ROCKY FLATS SITE REGULATORY CONTACT RECORD 2015-06

Purpose: Original Landfill (OLF) Implementation of Interim Action to Reestablish Surface Water Management on Portions of the OLF, with Soil Disturbance Review Plan

Contact Record Approval Date: July 28, 2015

Figure 1

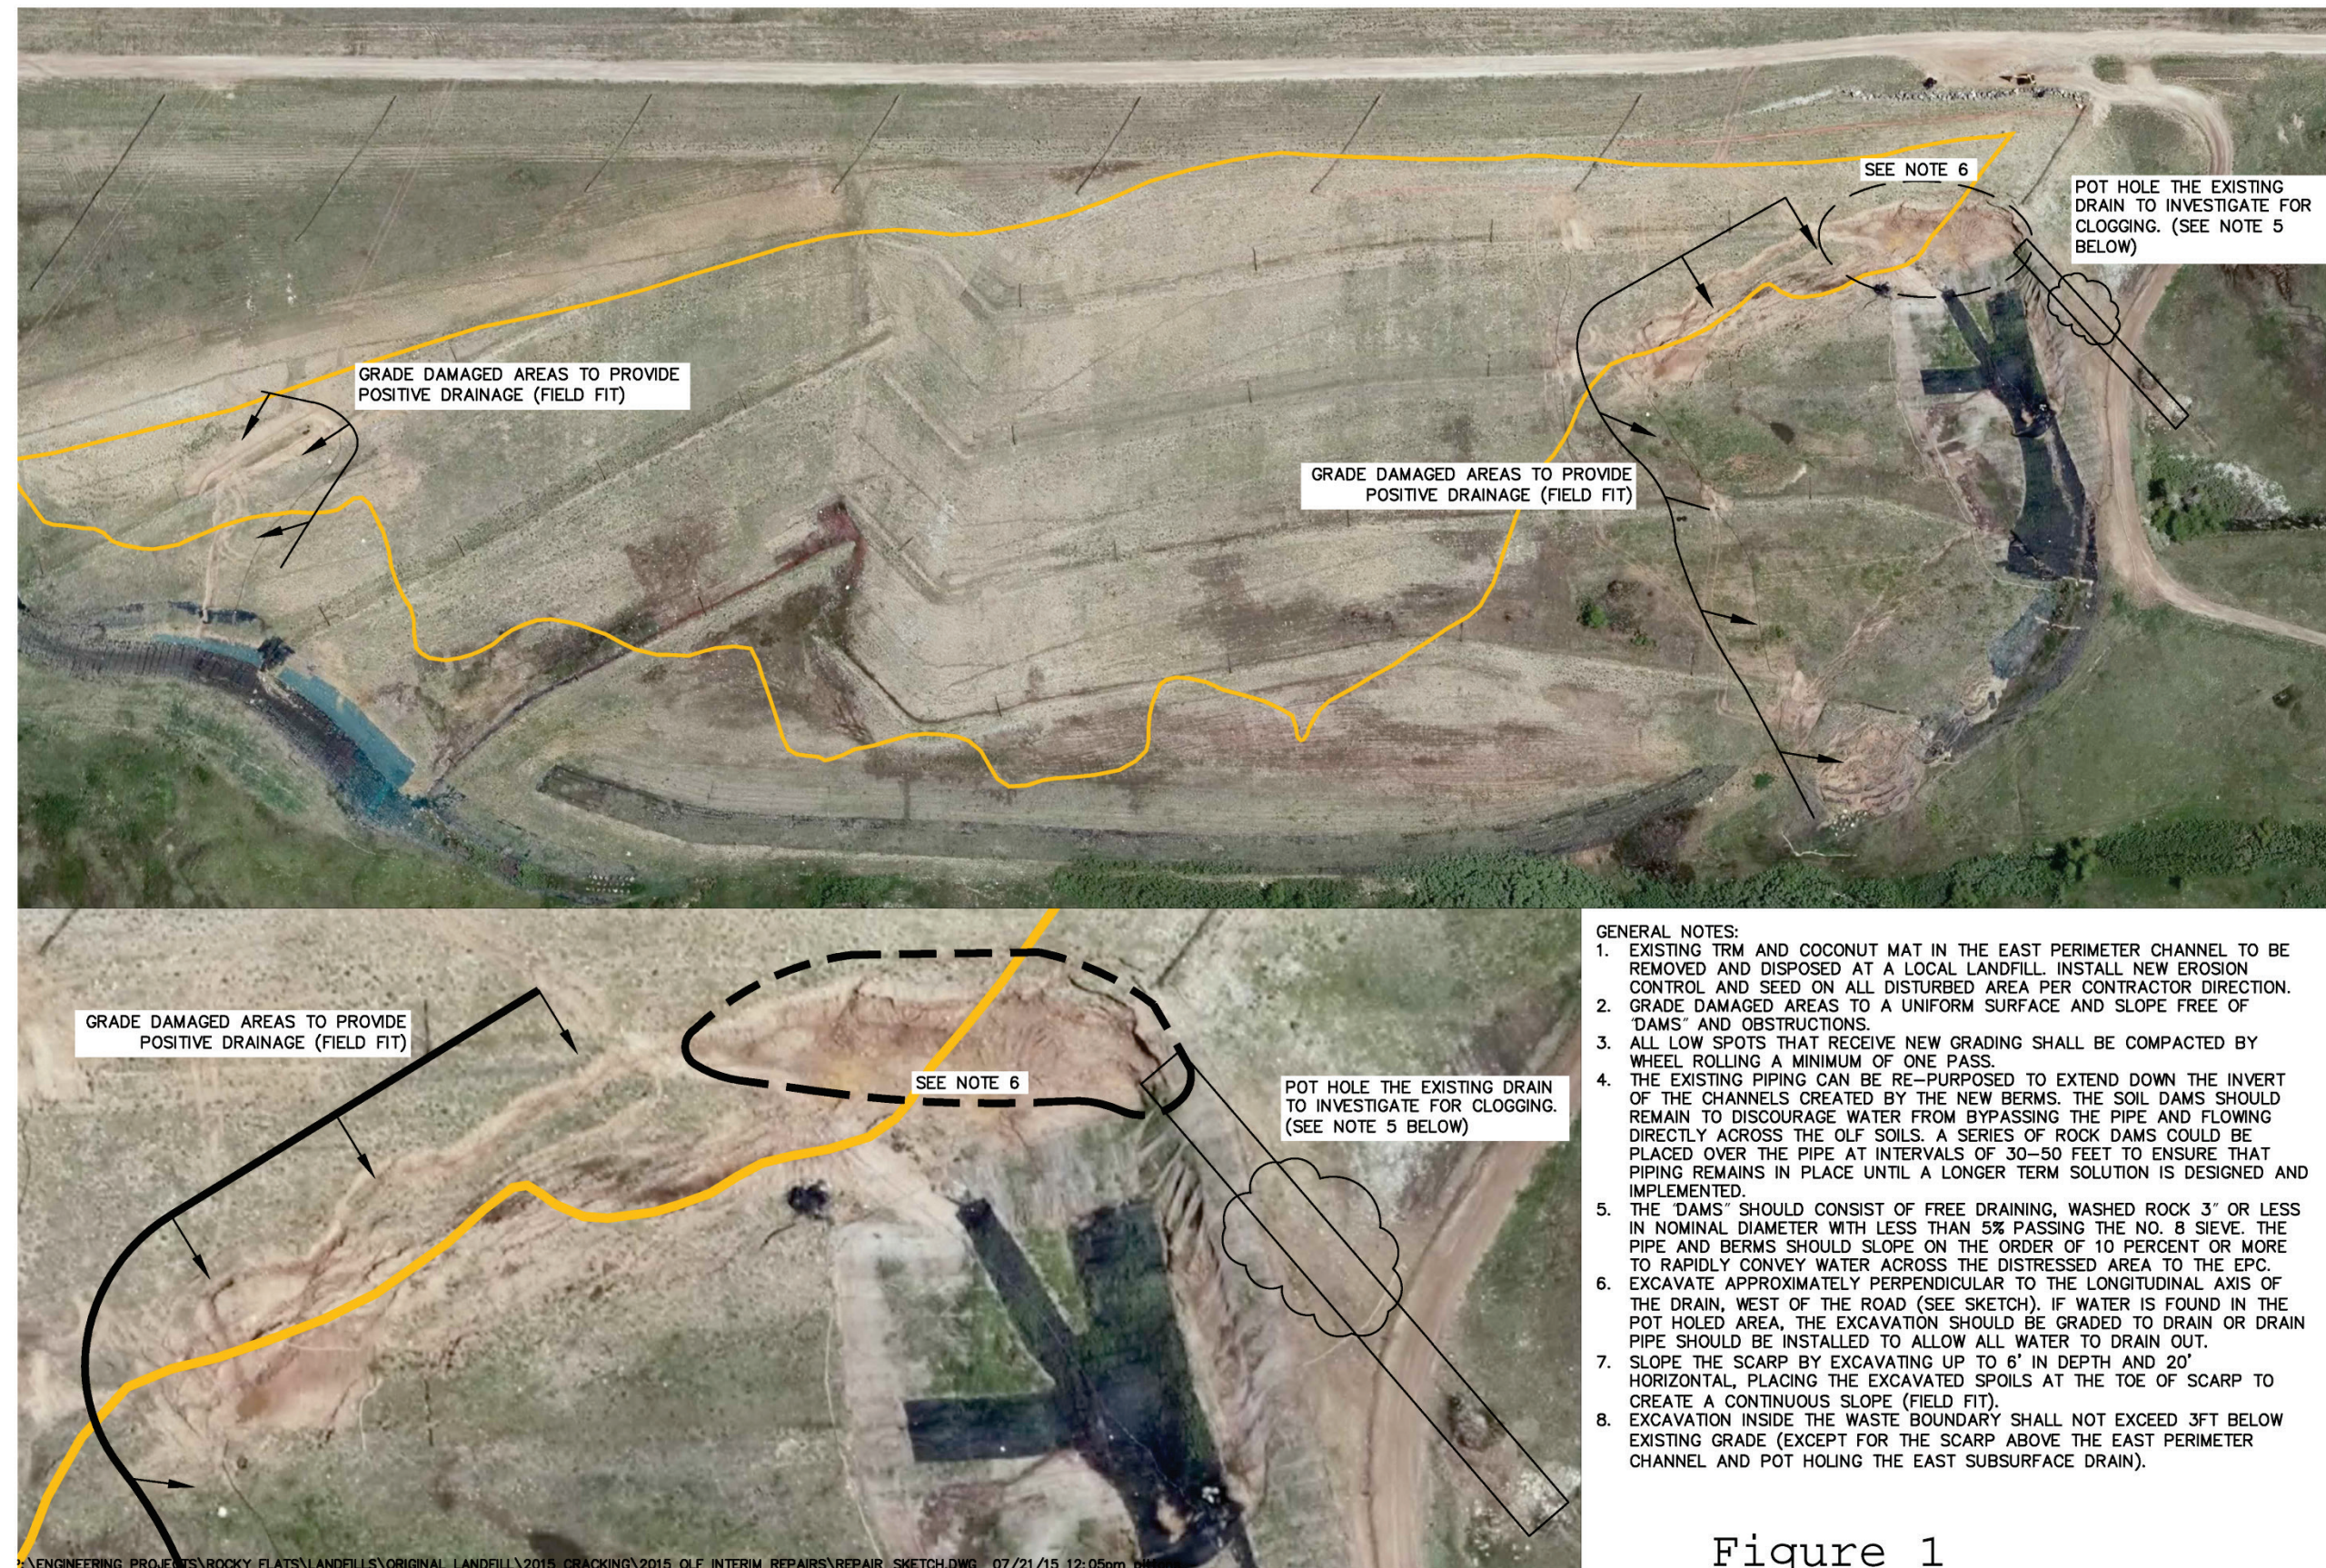
Discussion: A qualified geotechnical engineer with prior experience at the OLF visited the OLF several times and made several recommendations to address the need to reestablish surface water flow off the OLF cover over the short term. Recommendations included "laying back" the ground at the top of the largest scarp to achieve a more gentle and uniform slope. This will require cutting up to 6 feet off the top of the scarp and placing the cut material at the base of the scarp, which will lessen the potential for excess erosion on the steep face and the resulting potential for deposits of eroded soil that could hamper the flow of water. To achieve this slope, a "field fit" approach will be used rather than detailed engineered designs. Re-grading this area would also reduce safety concerns presented by the steep scarp (see Figure 1).

The area near the northeast edge of the OLF cover, where a rock drain was installed as a part of the OLF closure project, is very wet at the ground surface (see Figure 1). Observations by Rocky Flats staff and exploration using an excavator have shown that this drain appears to be at least partially blocked or clogged, hampering its effectiveness. The wet ground suggests the drain may be full of water that feeds permeable, low-strength lenses in the shallow soils. Excavation in the area to try to provide an outlet for water that may be collecting in the buried rock, thus providing a water source to the distressed areas, will be completed and will require an excavation of approximately 25 feet.

Although distress has been less extensive on the western side of the OLF, local instabilities and distress have been noted (see Figure 1). These areas will be mitigated in a similar manner for the short term (but will not require intrusive work focusing on a subsurface drain, as planned on the eastern side). Scarps, hummocky surfaces, and other slope irregularities can be smoothed and drain pipes installed to more rapidly convey water across the distressed areas until the subsoils have dried and a longer-term solution has been designed.

Contact Record (CR) 2015-06 Figure 1 shows the location and the lateral extent of the planned regrading, excavation, and soil disturbance. Laying back the largest scarp to achieve a shallower and more uniformly sloping configuration will require a cut of approximately 6 feet. Regrading the face of the cover as noted on CR 2015-06 Figure 1 will require a 3-foot cut at the edge of the waste footprint and in the EPC. The pothole indicated on CR 2015-06 Figure 1 will be approximately 25 feet deep.

The OLF is former IHSS 115. The OLF design had a 2-foot-thick soil cover over the location of the disposed waste materials and clean Rocky Flats Alluvium fill surrounding the waste materials for the placement and configuration of storm water and seep water management features. Limits of the waste area are shown in Contact Record 2015-06 Figure 1.

CDPHE approved the proposed activity stated in this CR on July 28, 2015.
